A d d e n d u m

Iowa Department of Transportation
Office of Contracts

B.O.	Proposal ID	Proposal Work Type	County	Project Number	Addendum
013	77-1945-738	Bridge Replacement - CCS	Polk	BRM-1945(738)--8N-77	20mar013.a01

TYPICAL STEEL TUBE RAIL FOOTING DETAIL

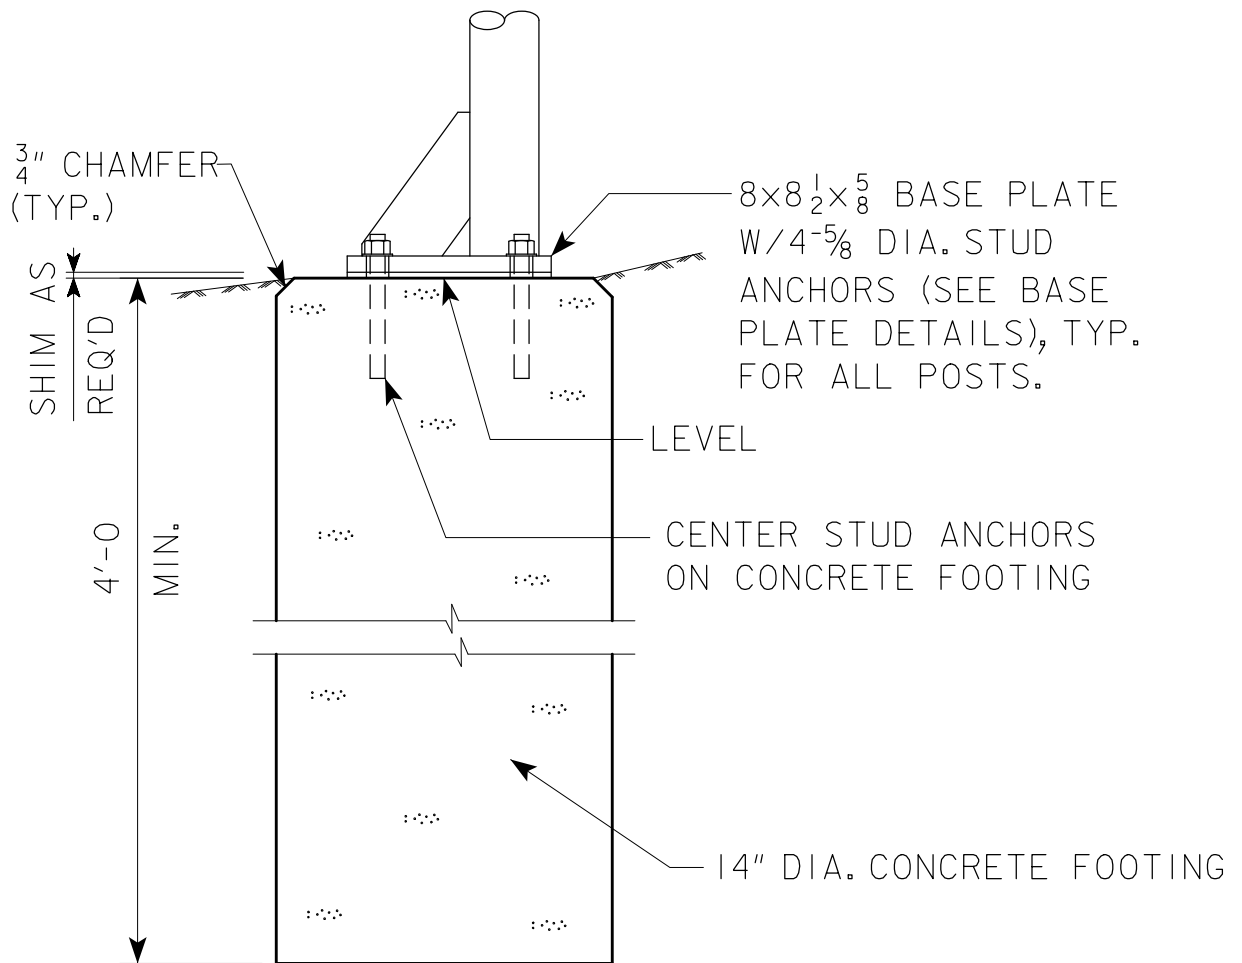
Add the attached Typical Steel Tube Rail Footing Detail.
